Access Compliance Report

Public Rights-of-Way (Curb Ramps)

Intersection ID: 9734	Main Street: FREEDOM_DR	Cross Street: S_I-85_HY	Location: NW
ADA ID: 241A8BD57B88	Ramp Type: Perp	Initial Pass/Fail: Fail	Overall Compliance: No Severity Score: 21.25

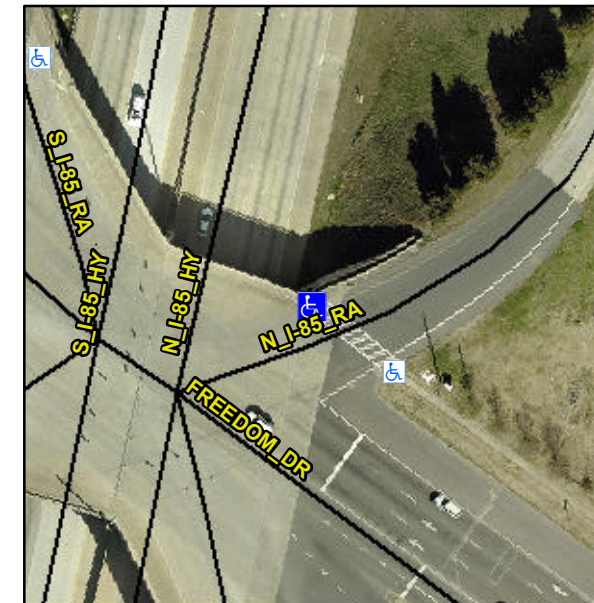
R304.5.1, R304.2.2

Compliance	Description	Data	Compliance	Description	Data
N/A	Ramp Length (in)	86.0	No	Ramp Slope (%)	9.0
No	Ramp Width (in)	46.0	Yes	Ramp XSlope (%)	1.2
N/A	Flare Type LT	N/A	N/A	Flare Type RT	N/A
N/A	Flare Slope LT (%)	N/A	N/A	Flare Slope RT (%)	N/A
N/A	Flare Traversable LT?	N/A	N/A	Flare Traversable RT?	N/A
N/A	Landing Length (in)	N/A	N/A	DWS Provided?	N/A
N/A	Landing Width (in)	N/A	N/A	DWS Contrast?	N/A
N/A	Landing Slope (%)	N/A	N/A	DWS Length (in)	N/A
N/A	Landing X Slope (%)	N/A	N/A	DWS Full Width?	N/A
N/A	Landing Curb? (Y/N)	N/A	N/A	DWS Offset (in)	N/A
N/A	Shared Landing?	N/A			
N/A	Gutter Ponding?	N/A	N/A	Gutter Slope (%)	N/A
N/A	Gutter Lip Ht (in)	N/A	N/A	Gutter X Slope (%)	N/A
N/A	Painted X Walk1?	Yes	N/A	Painted X Walk2?	N/A
	X Walk 1 Direction	To SE		X Walk 2 Direction	N/A
N/A	X Walk 1 Width (in)	109.5	N/A	X Walk 2 Width (in)	N/A
	X Walk 1 Slope (%)	0.7		X Walk 2 Slope (%)	N/A
	X Walk 1 X Slope (%)	2.5		X Walk 2 X Slope (%)	N/A

Remove & Replace Entire Ramp.
